REMARKS

Serial No. 10/801,178

Attorney Docket No.: HGM-135-A

FIG. 10

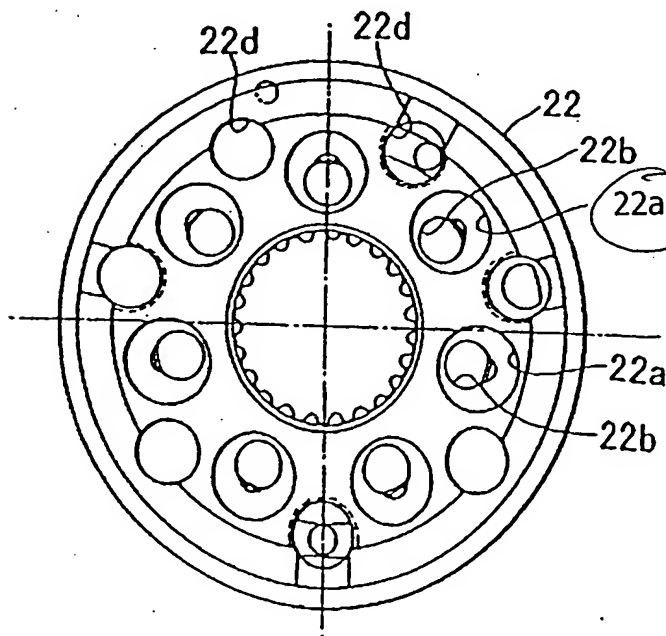
The drawings have been amended to correct minor informalities. Figure 1 is amended to eliminate two instances of duplicated reference numbers. In particular, duplicated reference number 21a (at the bearing) has been changed to 24, and duplicated reference number 31a (at the bearing) has been changed to 34. In Figure 10, erroneous referenced number 32a has been corrected to recite 22a.

The second attached sheet of drawings includes changes to Figure 10. This sheet, which includes both Figures 9 and 10, replaces the original sheet including both Figures 9 and 10. In Figure 10, erroneous referenced number 32a has been corrected to 22a.

Corrected
changed "32a"
to
"22a"
